Subject: Limerick Generating Station, Units 1 and 2
Response to Request for Additional Information Concerning
Technical Specification Change Request No. 93-19-0

Response to Request for Additional Information Concerning Technical Specifications Change Request No. 93-19-0 Submitted to Increase the Spent Fuel Pool Storage Capacity

FIGURE 17.3

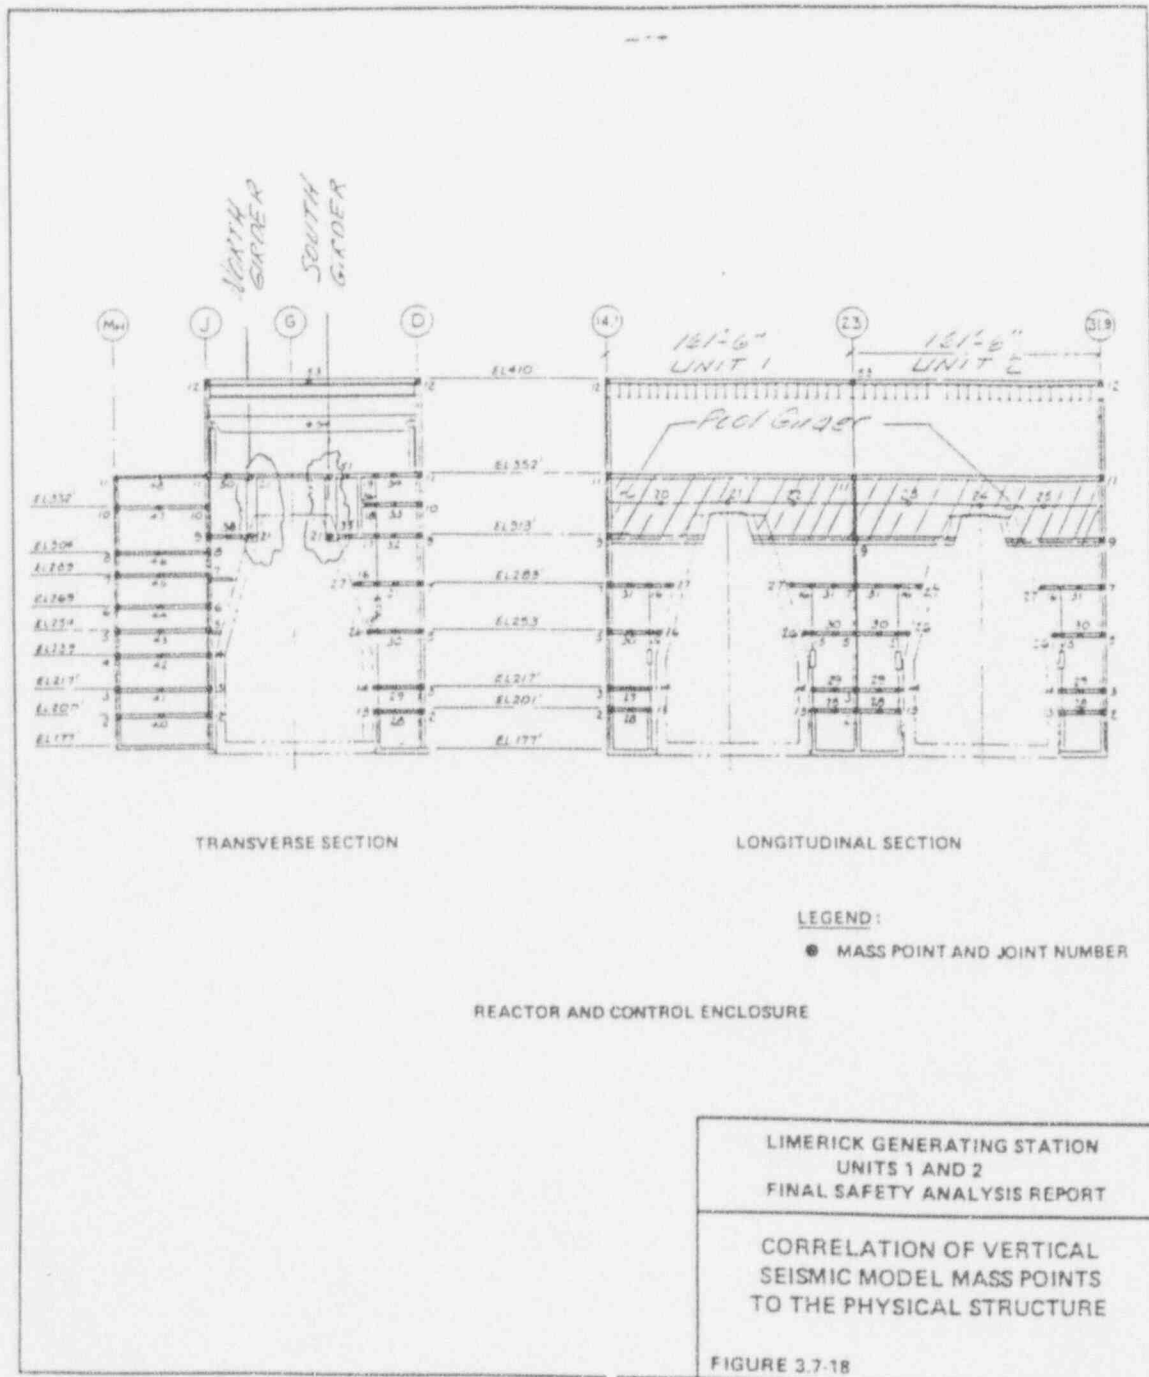
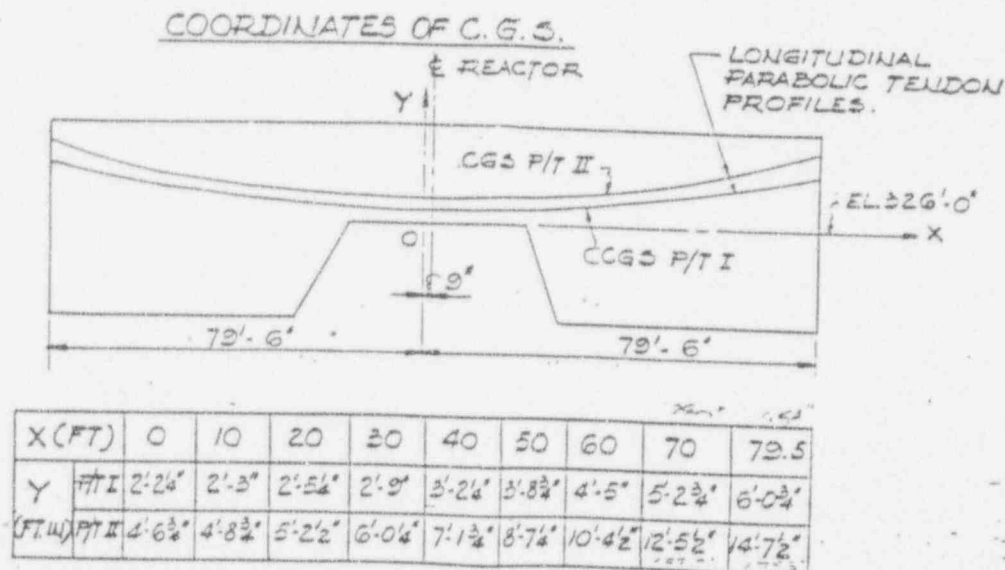
7. Description of boundary conditions used in the finite element analysis.
8. Discussion of torsional effects with regard to seismic response of the overall structure.

A copy of the LGS Reactor Enclosure Structure seismic analysis model is shown in Figure 17.3. This comprehensive model, in which both Unit 1 and Unit 2 structures are represented, was used to evaluate torsional effects due to eccentricities of mass and rigidity as part of the original seismic design of the plant. Results of those studies have shown that torsional effects are negligible. As can be seen from the referenced sketch, the building is approximately symmetrical and effects of eccentricities are inherently accounted for in the analyses.

FIGURE 17.4

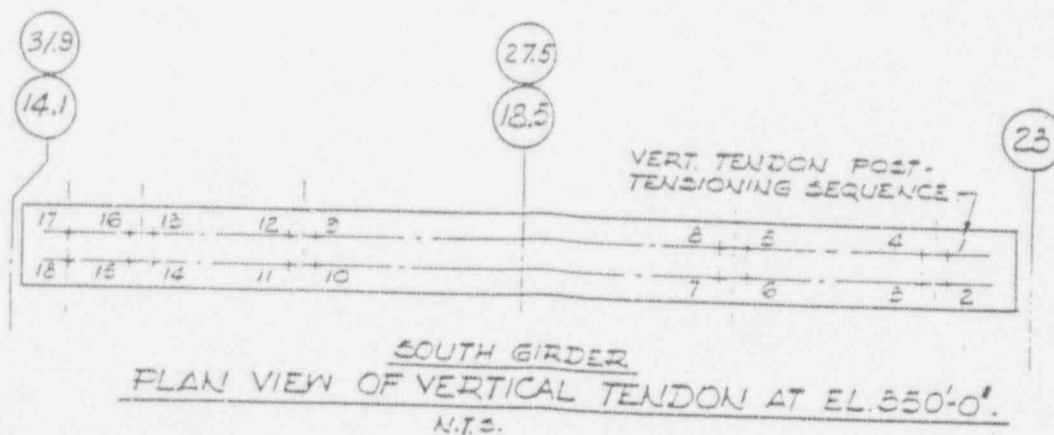
- e. Provide the temperature profiles with magnitudes used for the pool's slab and walls analyses.
- f. The submittal (pages 8-10) does not present any analysis of the post-tensioned girder when subjected to the SSE loading. Indicate whether or not the SSE loading was considered in the post-tensioned girder analysis. Provide the results of the girder analysis for the SSE loading case.

- Refer to Figure 17.4

FIGURE 17.5 (Page 1 of 2)

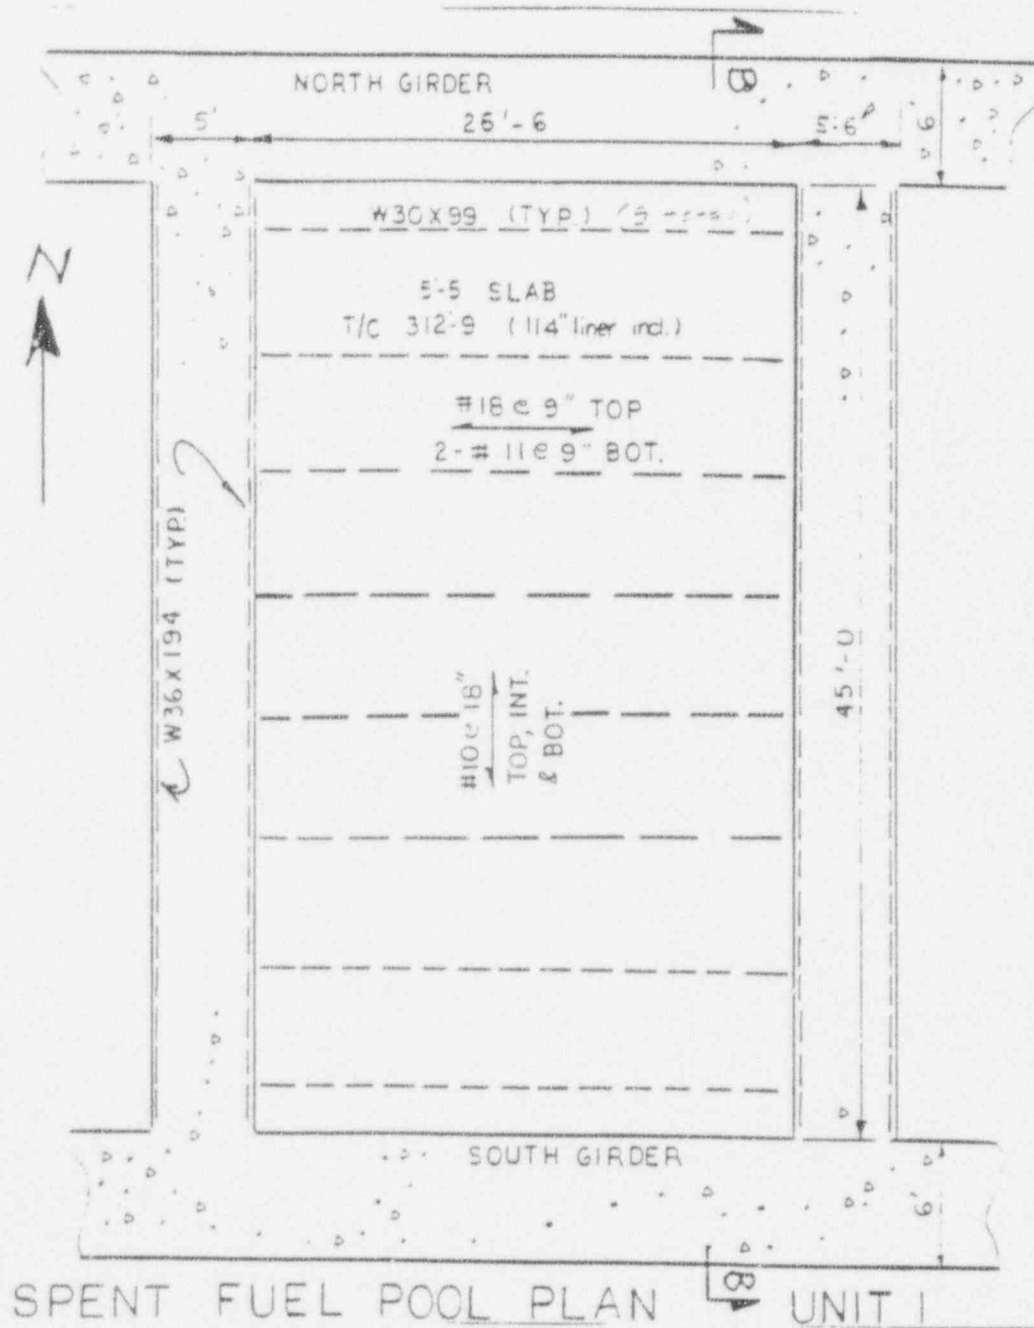
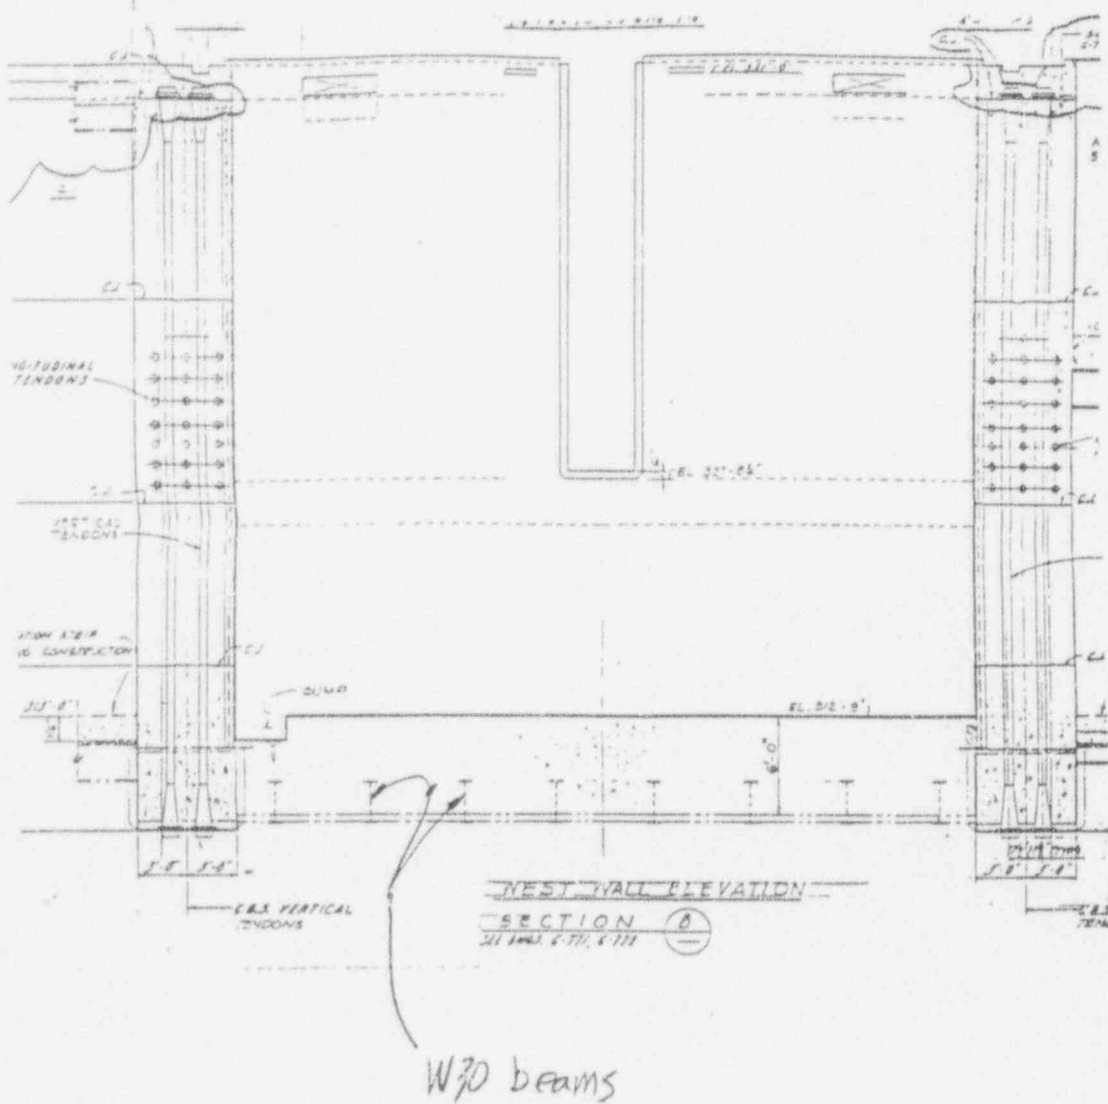
- 1. Description of spent fuel pool structures including an explanation of the support mechanism for the pool slabs.
 - 2. Key assumptions.
 - 3. Material properties.

- Decking laid on beam's bottom flange to support wet concrete weight.
- Refer to SFP Plan (see Figure 17.5).
